**PERMANENT PUMP STATION B
CONSTRUCTION PERMIT APPLICATION
RESPONSES TO THE FLORIDA DEPARTMENT OF
ENVIRONMENTAL PROTECTION
LETTER DATED NOVEMBER 25, 1997**

Subject: Response to Florida Department of Environmental Protection's letter dated November 25, 1997, regarding the Southeast County Landfill (SCLF), Pump Station B Construction, Pending Permit No. 35435-0001-SC, Hillsborough County, Florida

TOP VAULT OPENING

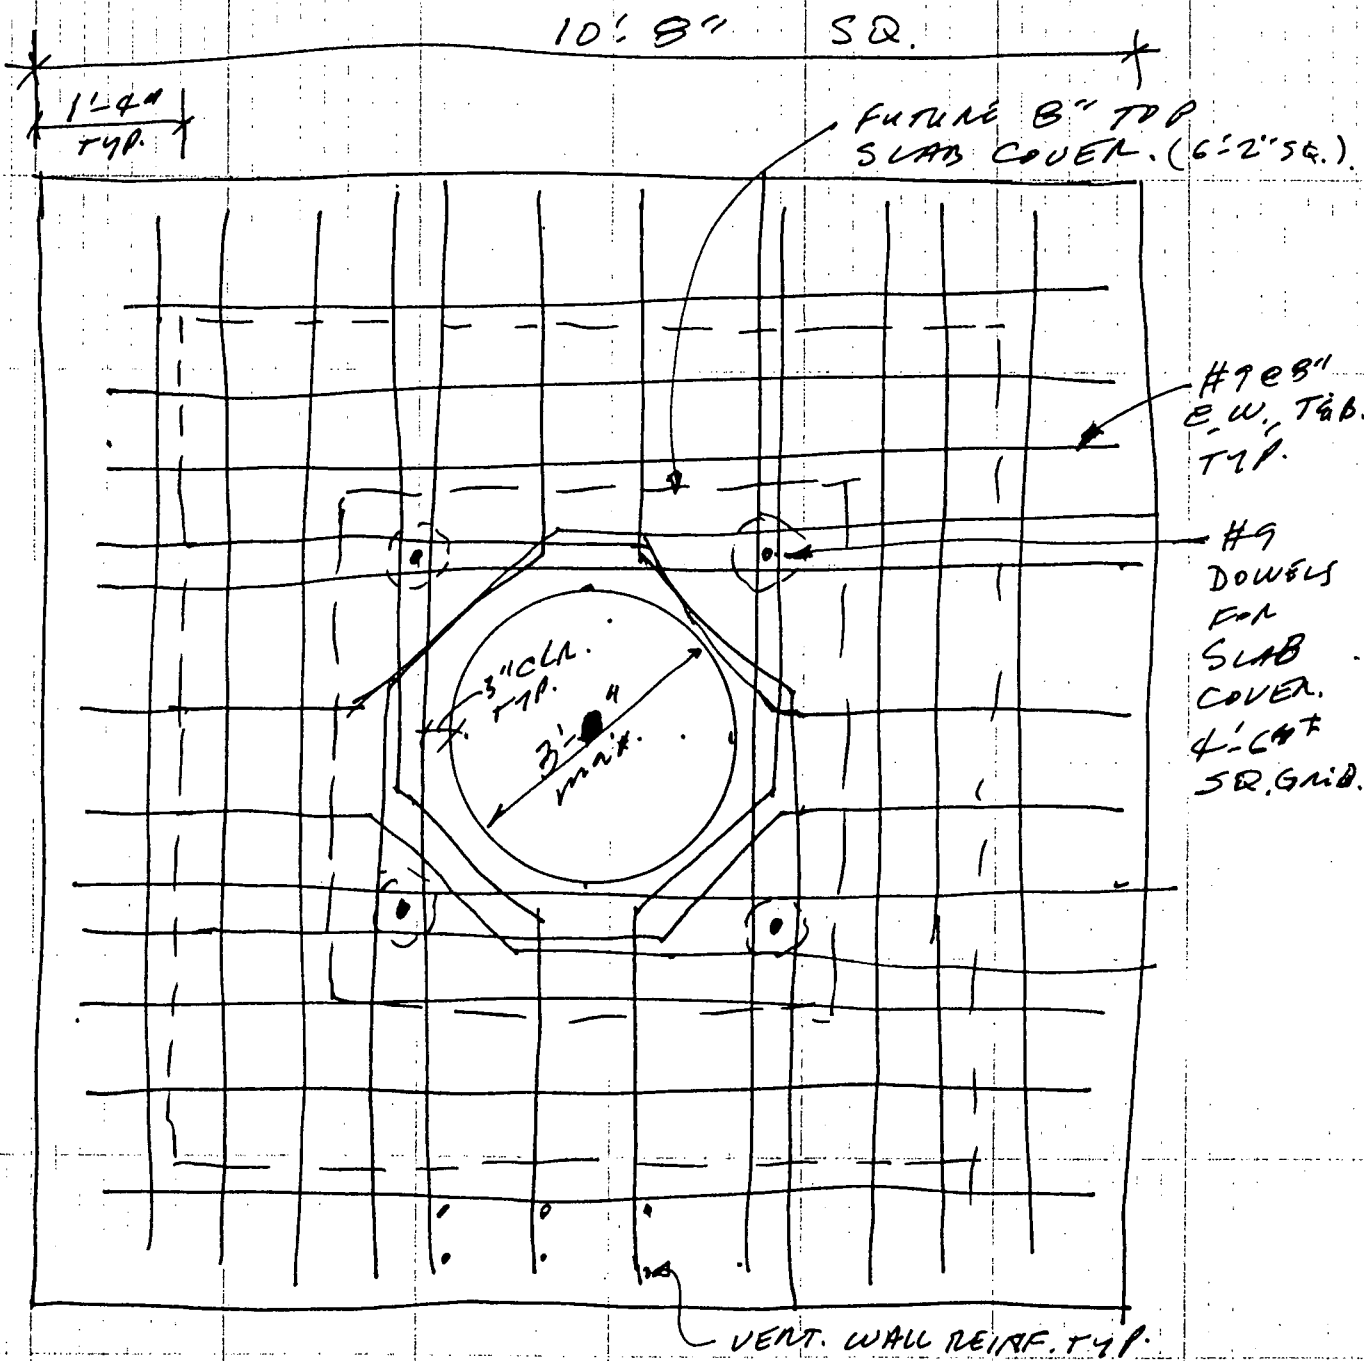
As requested by the FDEP in our meeting on November 25, 1997, the vault has been modified to include an opening at the top, as shown on Drawing No. 7 of the Construction Permit Application (Attachment 1) to allow the HCSWMD to evaluate the performance of the vault before waste is placed in Phase VI. In addition, as we discussed, Drawing No. 4 was revised to eliminate the 90 degree connection from the eastern LCRS pipe (Attachment 1).

For observation prior to backfilling the vault, placing a 3' diameter hole on the top of the vault is possible. Covering the opening with a future precast slab is acceptable. Enclosed are sketches for the reinforcement that is required for this opening and the future slab.
